**Town of Kittery
Planning Board Meeting
October 26, 2023**

ITEM 3 – 47 Cutts Road – Major Conservation Subdivision Plan – Preliminary Review

**RE: Town of Kittery, Planning Board Services
Cutts Road Major Conservation Subdivision – Preliminary Review
47 Cutts Road, Tax Map 60, Lot 10-3
CMA #591.164**

EMBANKMENT CONSTRUCTION NOTES

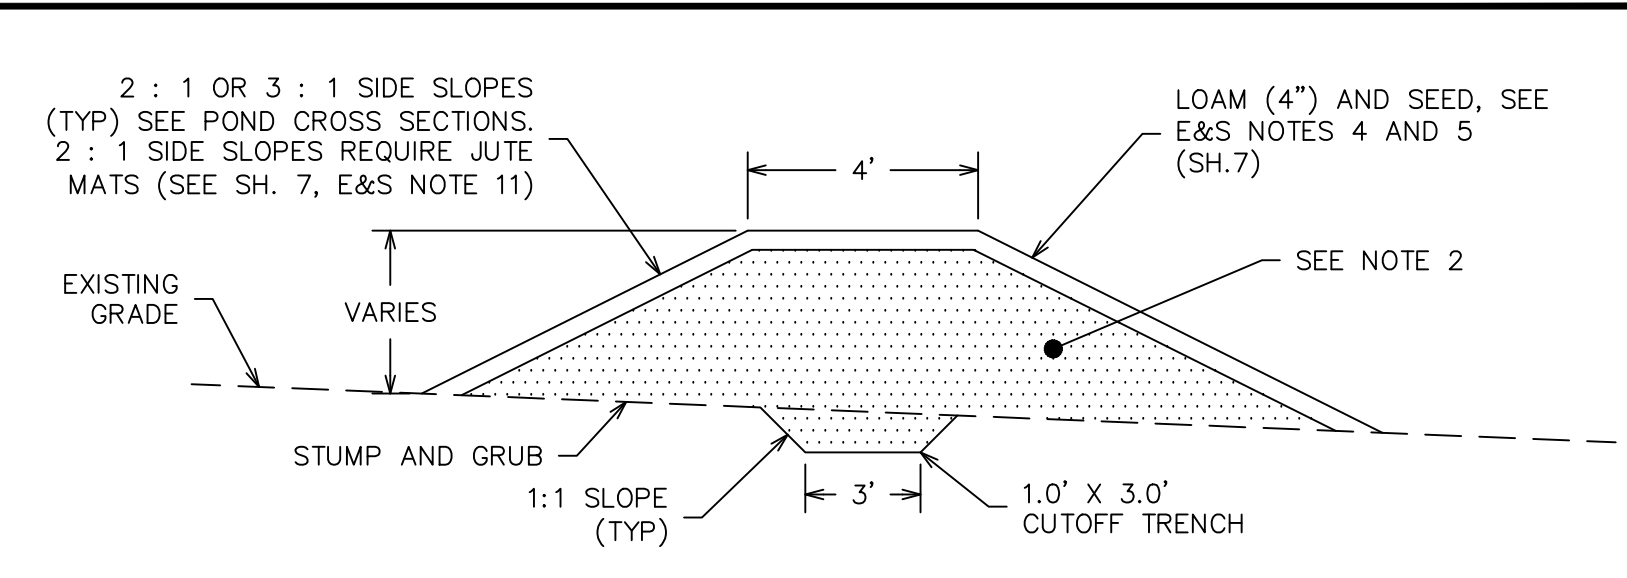
1. The stormwater management ponds should be numbered on the plans to coincide with the drainage report.
2. The peak storm elevations for Detention Pond #4 on Sheet 11 Site Details, provided with the drainage analysis, are incorrect.

1. The Road Cross Section should be updated to reflect the Department of Public Works and Fire Department comments.
2. The Utility Trench Patch Detail should have base and finish course information not "per Kittery DPW specs".
3. The water line detail should include warning tape.
4. There should be a detail for the water main connection in Cutts Road.
5. There should be details for the SSWDS – piping, pumps, etc.
6. There should be detail for water main fittings/bends.
7. There should be a detail for thrust blocks.
8. There should be a hydrant detail.
